ACCELERATOR DEPARTMENT  
Internal Report

SHIELDING OF THE 200-MEV LINAC

May 18, 1966

Erratum

Figure 1 Neutron flux on inside of shield wall and attenuation length in ordinary concrete vs. length along the linac for a continuous loss of  $1.8 \times 10^{13}$  protons/sec.

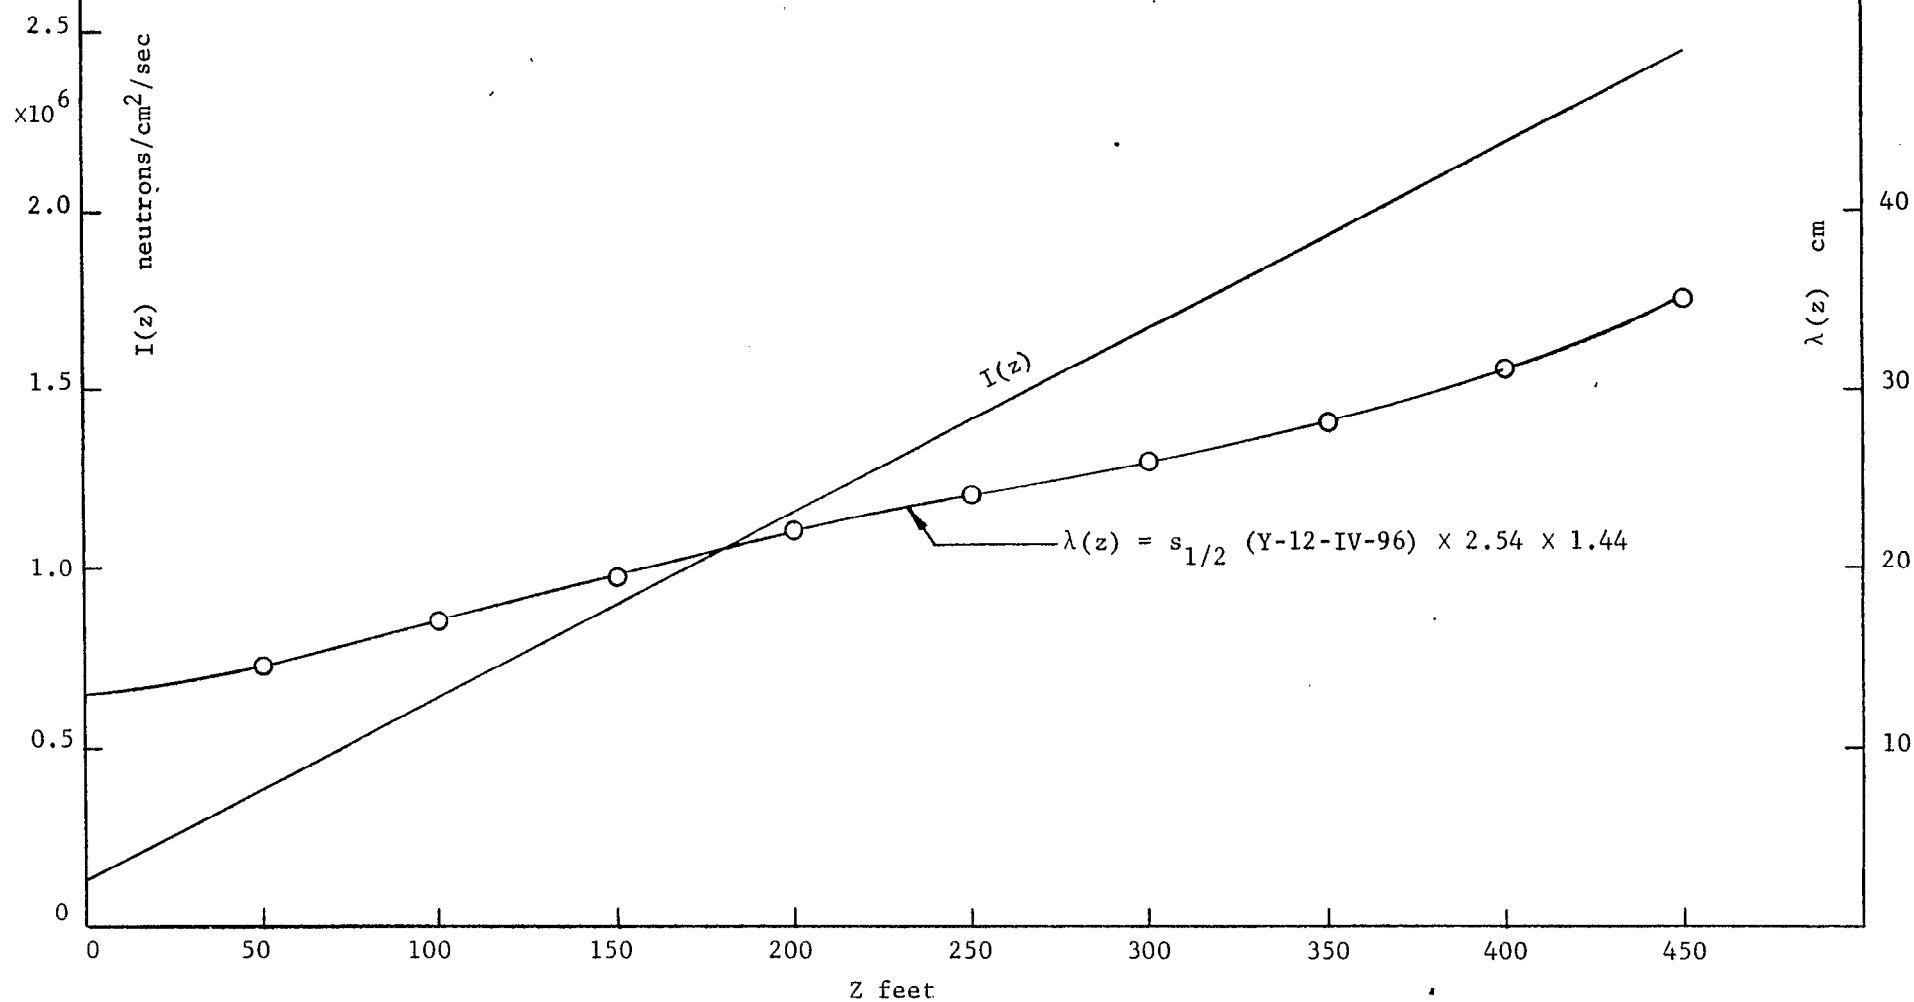
On page 8 of this report there is an error in the expression for the neutron flux at the inside of the shield wall ( $I_z$ ). On the assumption of an infinite line source, it is stated that

Thus, the values of  $I_z$  used in the report are high by a factor of 8. At either end of the linac, Eq. (A) still overestimates the flux by a factor of 2 because the source becomes a semi-infinite source (the integration is carried from 0 to  $\infty$ ). However, this overestimate is compensated at the high energy end

The overestimate by a factor of 8 amounts to almost 4 feet of sand thickness and it is recommended that the shield wall thickness be reduced by this amount.

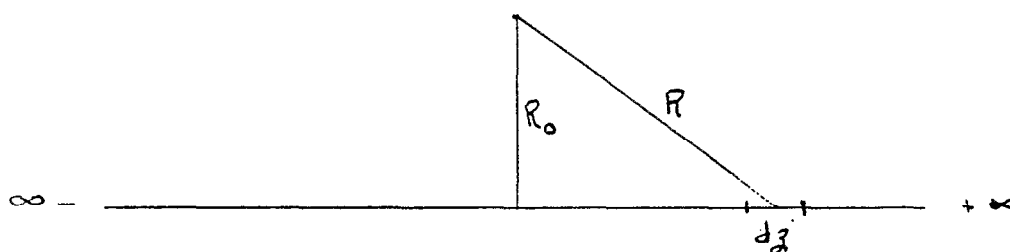
$$I_z = \frac{2S}{R_0}$$

The correct expression is given below, see figure.

$$I_z = \int_{-\infty}^{\infty} \frac{Sdz}{4\pi R^2} = \frac{S}{4\pi} \int_{-\infty}^{\infty} \frac{dz}{R_0^2 + z^2} = \frac{S}{4R_0}, \quad (A)$$

where the value of  $S$  used is that appropriate to the length,  $z$ .
